From: edkcnw@comcast.net
Sent: Wednesday, March 24, 2021 12:51 PM
To: Tabitha Boschetti
Cc: Lindsey Hagerman; Steve Koper
Subject: RE: Public Comments- Notice ANN 20-0004- 23500 SW Boones Ferry Rd.

We appreciate the opportunity to provide Citizen Comments regarding the proposed ANN 20-0004 - Annexation of 23500 SW Boones Ferry Road by CPAH into the City of Tualatin.

LEA Comments
On the Draft Tualatin Stormwater Master Plan
(Dated April 2019)

Figure 16. ORIGINAL Configuration - Velocities at Likely Flows 25-yr Design Storm Event
Upstream and Downstream Stations along the Lucini property approximate 150-foot Ditch

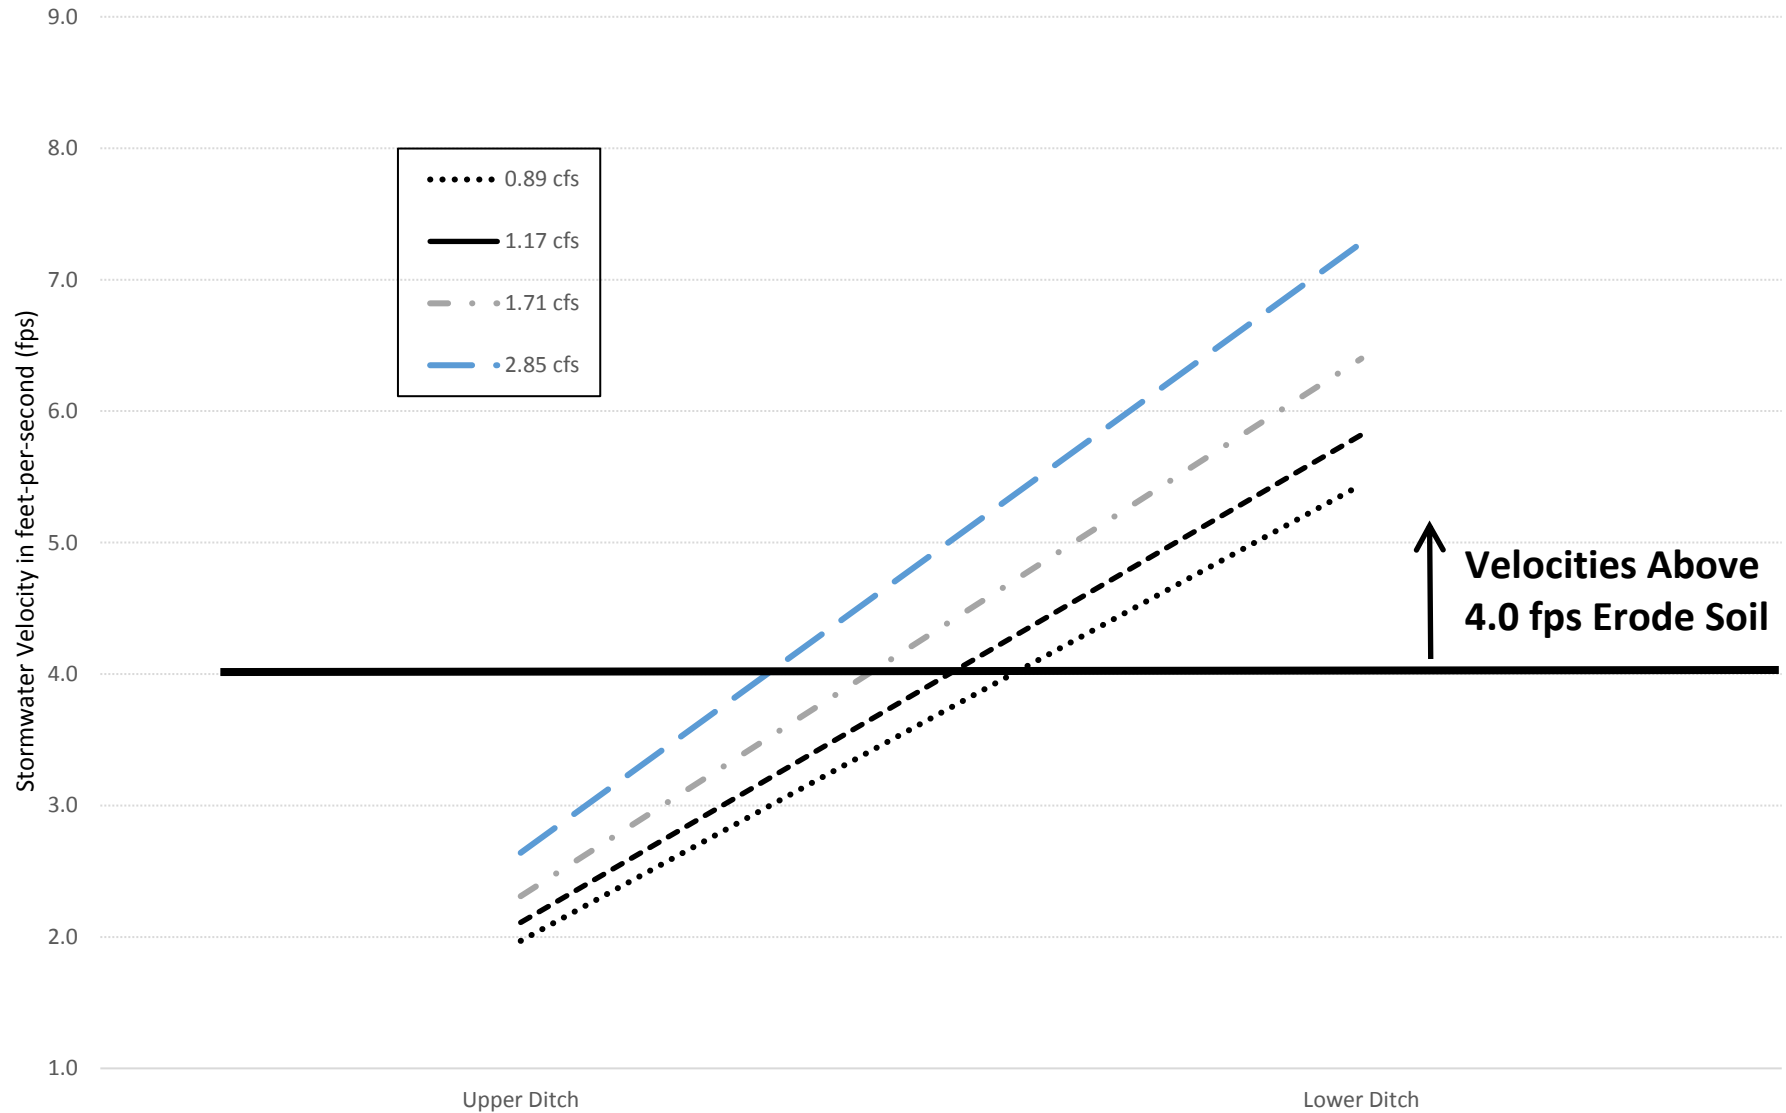
Stormflow velocities shown in Figure 16, for a range of land use conditions and the ORIGINAL subbasin configuration, demonstrate many instances where values exceed velocities that cause erosion on the Lucini property. These velocities exceed 4.0 feet-per-second (fps) and cannot be maintained. This deleterious situation requires measures to reduce peak flows coming through the County's culvert (Outfall #5) and onto the Lucini property. The physical conditions of excessive and increased streamflow on steep slopes existing on the Lucini property, and compared to the ORIGINAL conditions, were not evaluated by the County in its Drainage Report.

Figure 16 for the ORIGINAL configuration illustrates velocities for the upstream and downstream stations along the Lucini property approximate 150-foot ditch²⁷. This figure shows that as stormflows increase from 0.89 cfs to 2.85 cfs, highly erosive storm velocities occur.

As charted in Figure 16, flow velocities in excess of 4.0 feet-per-second (fps) produce adverse conditions that erode soil.²⁸ This is consistent with the stormwater damage to the ditches, and pipe blockage, on the Lucini property (see photos in Appendix A2).

Figure 17. IMPLEMENTED Configuration - Velocities at Likely Flows 25-yr Design Storm Event
Upstream and Downstream Stations along the Lucini property approximate 150-foot Ditch

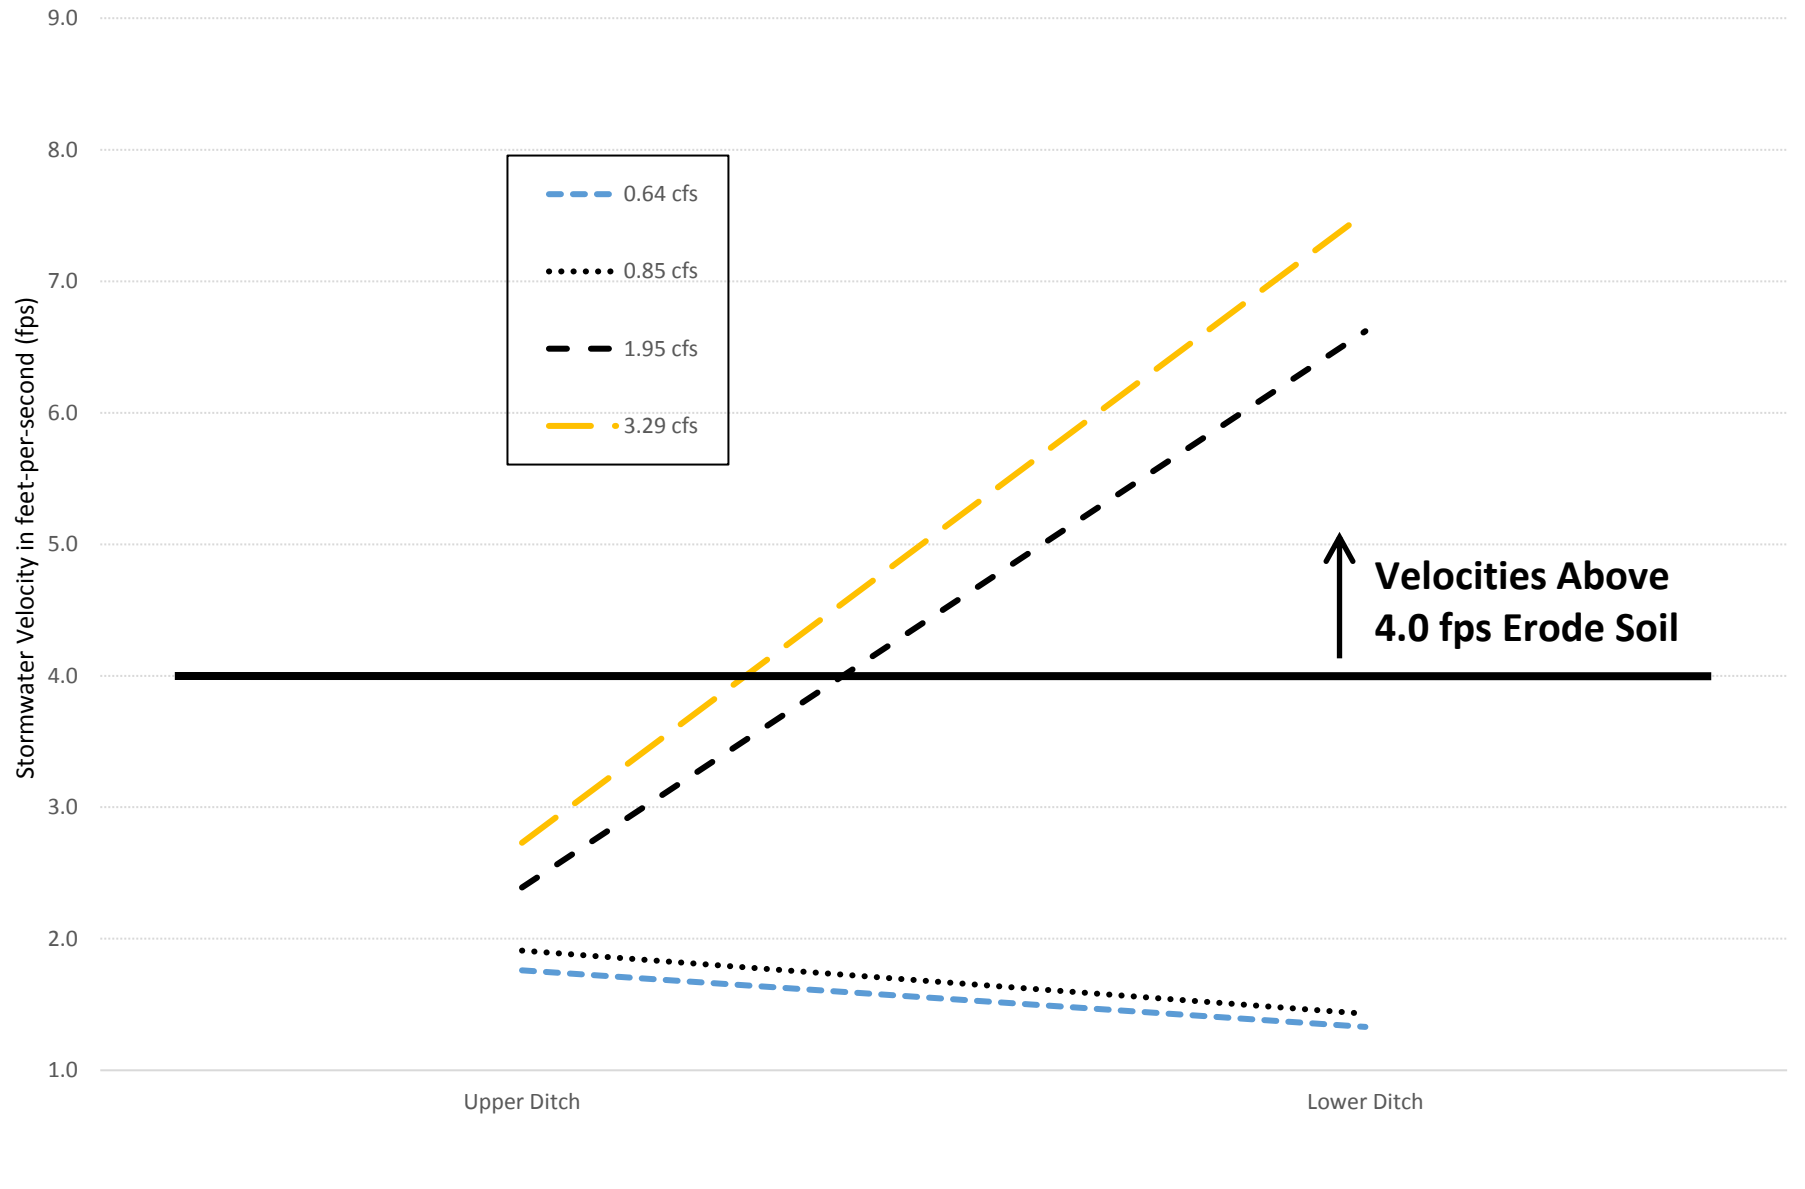
Stormflow velocities shown in Figure 17, for a range of land use conditions and the IMPLEMENTED subbasin configuration, demonstrate that values exceed velocities that cause erosion on the Lucini property for the ongoing land use and full build-out development conditions. These velocities exceed 4.0 feet-per-second (fps) and cannot be maintained. This harmful condition requires methods to reduce peak flows, including sediment and debris transport, passing through the County's culvert and onto the Lucini property. The physical conditions of excessive and increased streamflow on steep slopes existing on the Lucini property, and compared to IMPLEMENTED conditions, were not evaluated by the County in its Drainage Report.

Figure 17 for the IMPLEMENTED configuration illustrates velocities for the upstream and downstream stations along the Lucini property approximate 150-foot ditch. This figure shows that as stormflows increase from 0.85 cfs to 3.29 cfs, highly erosive storm velocities will occur into the future.
